COUNCIL ASSESSMENT REPORT

SOUTHERN REGIONAL PLANNING PANEL

| PANEL REFERENCE & DA NUMBER | PPSSTH – 330/ DA.2023.0602/ PAN-394183. |
| PROPOSAL | Shoptop Housing Development and Amendment (under Section 4.17(1)(b) of the EP&A Act) to DA 950033 for the Riverside Plaza extension |

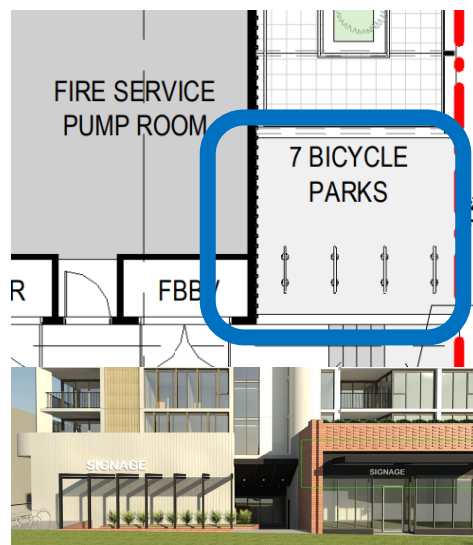
As raised in a previous RFI to the Applicant, there is a small portion of the western part of the Morisset Street frontage which is not defined as active. The area of concern is the bicycle parking which is not an entrance, lobby, vehicle access or access for fire services. A minor amendment could be made in this location to activate this small part of the frontage, but such a change was not made by the Applicant following the RFI. Further, a large part of this frontage is the disabled ramp down to the sunken lobby. Concerns have been raised by Council regarding this lobby and prior suggestions to raise the finished floor level have not been addressed. Council considers this part of the Morisset Street elevation could be better rationalised to provide a more active and inviting street frontage and entrance to the building.

Figure 10 Section D east/west through the building – southern end (Source: Applicant's Clause 4.6 Variation)

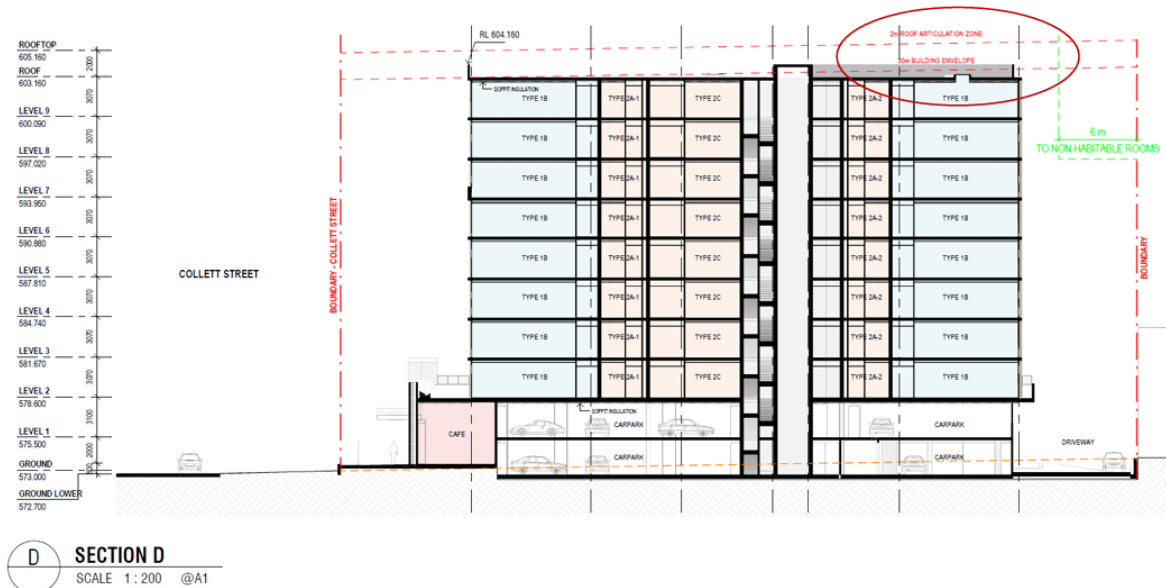
The application proposes to vary the height of building development standard applying to the site. The QLEP height of building development standard is 30 metres, and the application proposes a maximum height of building of 30.9m. This is a numerical variation of 3%.

- The contravention is minor and does not include any habitable floor space.
- The contravention of the standard is a result of minor variations to site topography and the design of the building to achieve a form where the two towers are symmetrical.
- Reduction in the height of the building is not considered to achieve a superior design or planning outcome.
- The additional height will not be perceptible from street level.
- The variation will result in a more orderly and economic development of the site within the context of the objects of the Act.

Council is therefore satisfied there are sufficient environmental planning ground to support the minor contravention to the height of building standard in the QPR LEP.

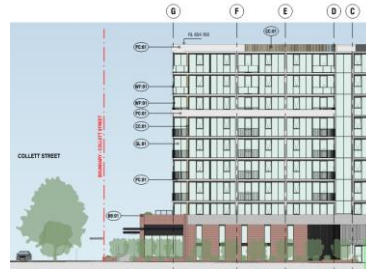
The setbacks to the north are equally inconsistent with the ADG, as with the western elevation. However, the minor reduction at the upper 2 levels is not considered to be material given the site to the north, being heritage listed Hibernia Lodge, is not identified for demolition and redevelopment for residential flat development. At those upper levels, there is therefore no risk of adverse amenity outcomes.
